## **Product Modification Notification**

Stepper Motor Specification Change Notice

NEW

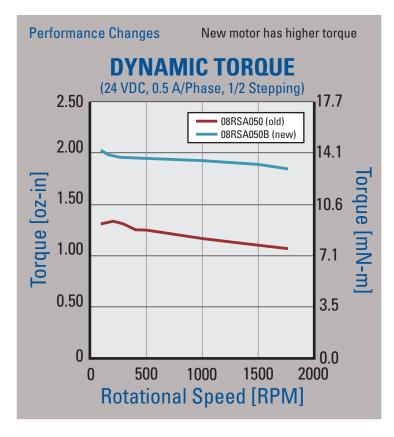
More compact stator laminations

Thicker front end cap

Lead screw retaining fastener now uses socket head cap screw instead of flathead
